R113 Ductless Heat Pump Evaluation

Connecticut Energy Efficiency Board (EEB)

Prepared by DNV GL under subcontract to NMR Group, Inc.

March 13, 2016

Figure 5. Composition of sample and respondents

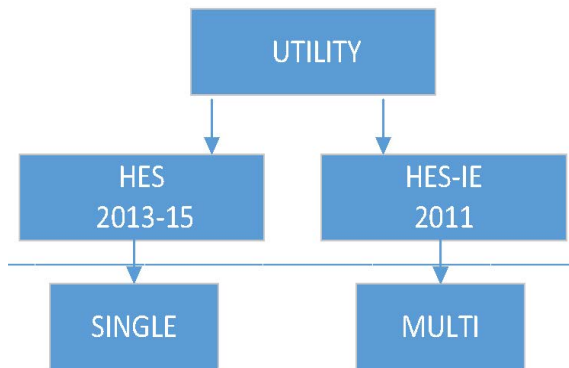
Comment [GR21]: So does the MF vs. SF focus of the two samples have any relevance to the savings results and RRs?

Comment [GR22]: Were only HES-IE MF DHP participants included in R16?

Comment [GR23]: Many/most of whom were SF?

Figure 6. Function of the DHP and load served

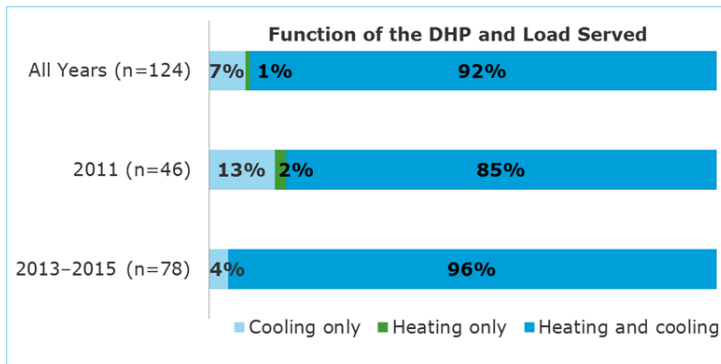
Comment [GR26]: Again, were all 2011 DHP participants HES-IE MF?

Figure 7. Pre-existing space conditioning

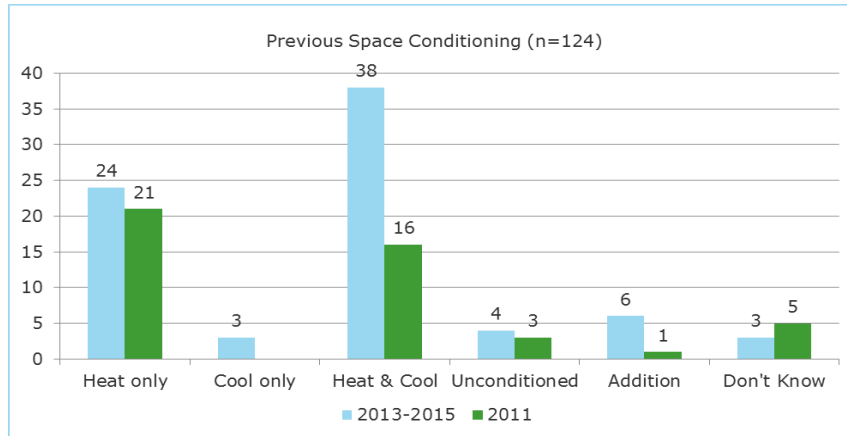
Comment [GR27]: If all of 2011 sample was HES-IE MF then surprised to see any installations in previously unconditioned space. Or in an addition.

Figure 11. Integration of DHP with the pre-existing heating system

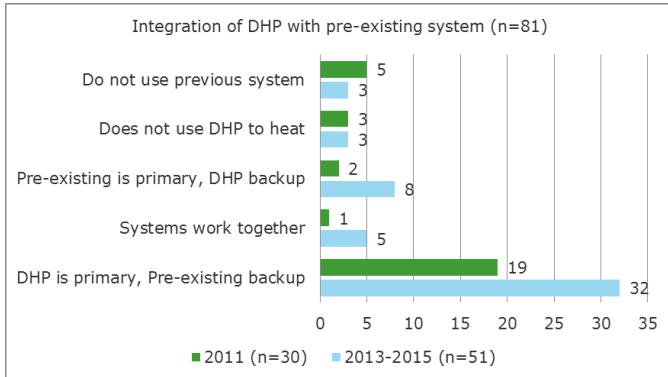
Comment [GR29]: Is there any information on the hardware, i.e., thermostats, used to effect this integration?

Figure 13. Seasonal cost of producing 100k BTUs with oil boiler and DHPs

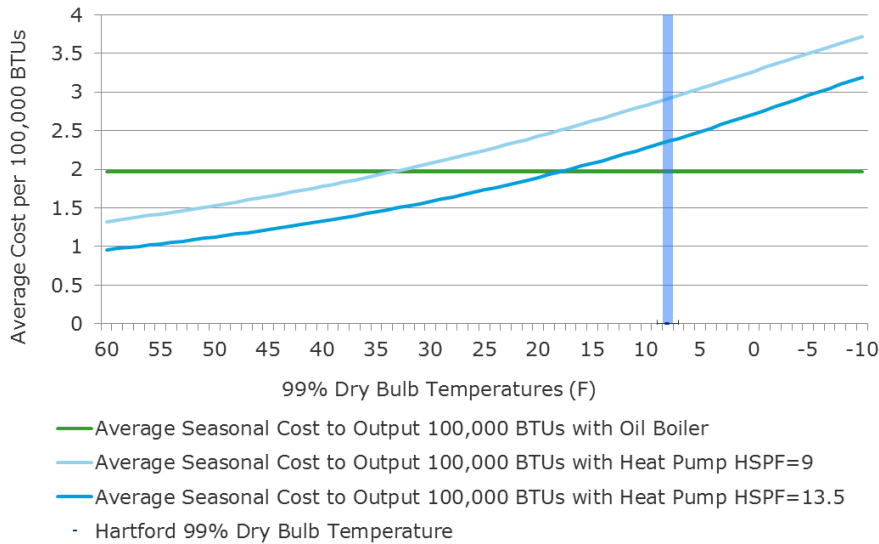
Comment [GR32]: Of what system efficiency?

Comment [GR33]: So what is the % decrease for Hartford?
